SUBJECT: AMENDMENT NO. 80 TO FACILITY OPERATING LICENSE NO. NPF-3;
CYCLE 5 OPERATION

DAVIS-BESSE NUCLEAR POWER STATION, UNIT NO. 1

Amendment No. 80
License No. NPF-3

SAFETY EVALUATION BY THE OFFICE OF NUCLEAR REACTOR REGULATION
SUPPORTING AMENDMENT NO. 80 TO FACILITY OPERATING LICENSE NO. NPF-3

Axial Power Imbalance Limits, 0 to 25+10/-0
EFPD, Three RC Pumps -- Davis-Besse 1,
Cycle 5

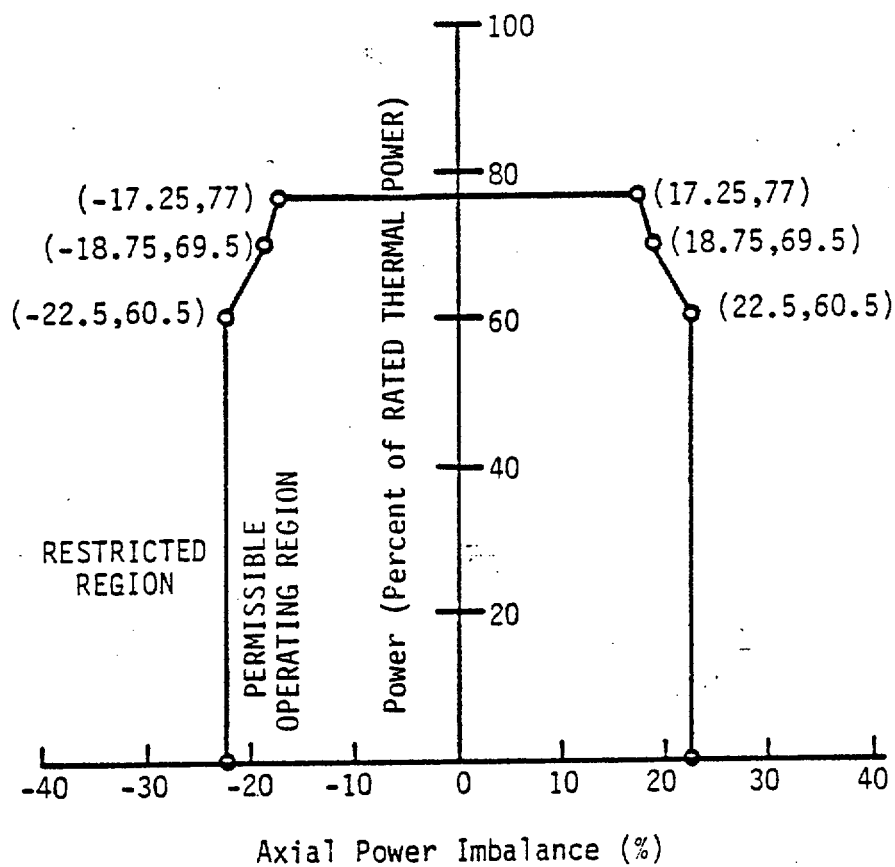
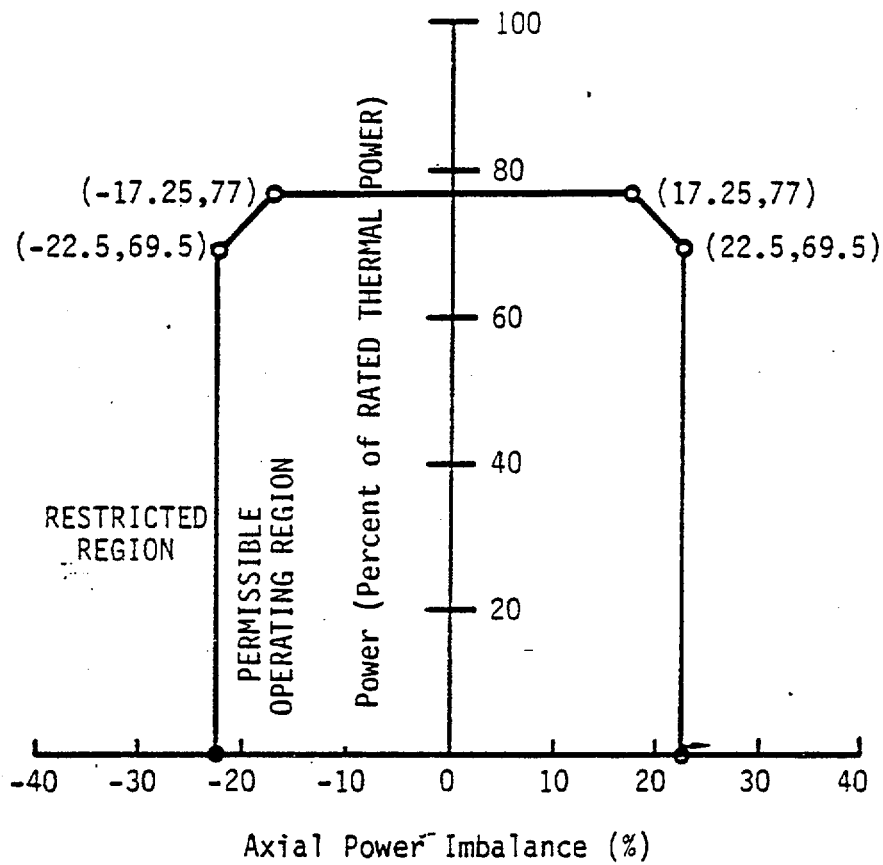
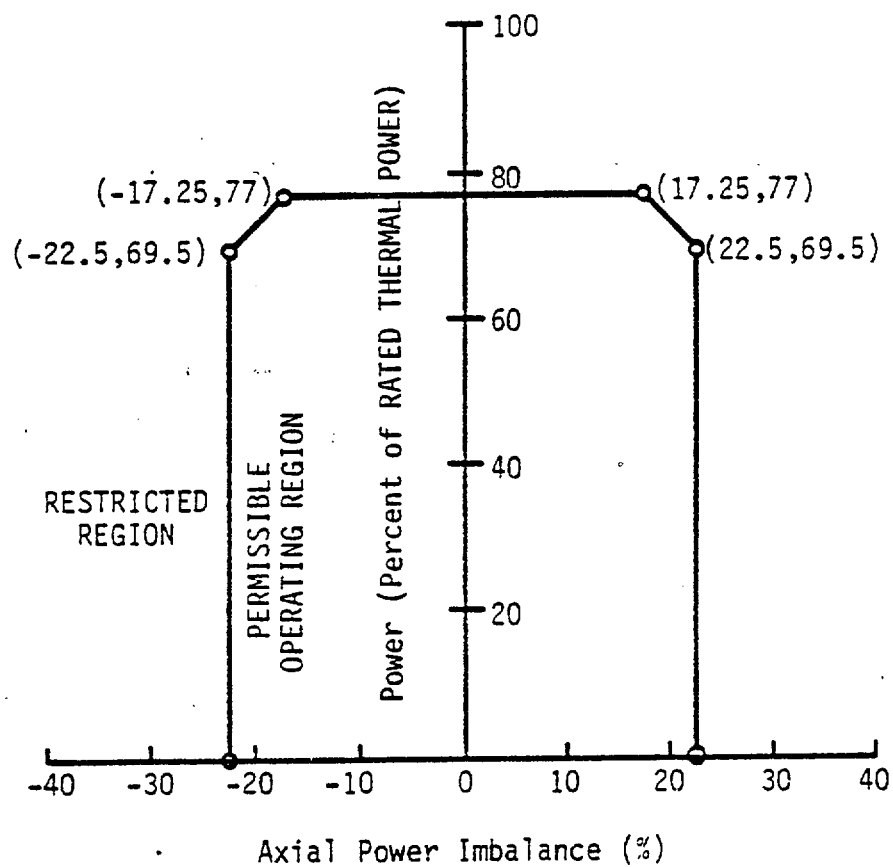
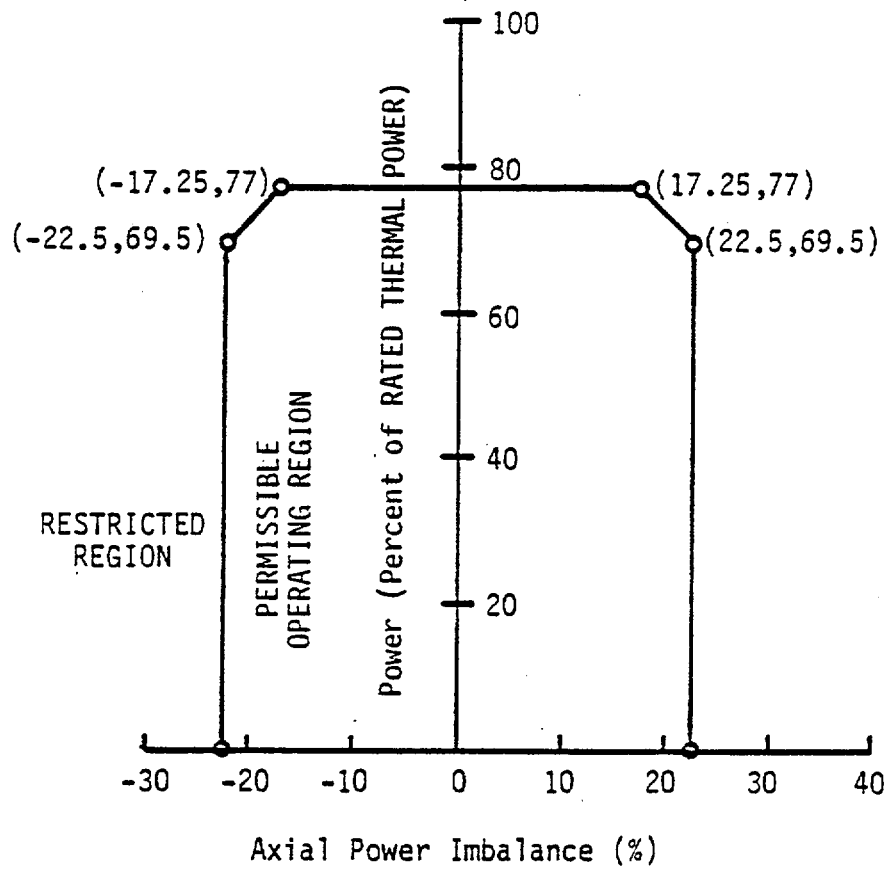
3.2.1 AXIAL POWER IMBALANCE shall be maintained within the limits shown on Figures 3.2-1a, -1b, -1c, and -1d and 3.2-2a, -2b, -2c and -2d.
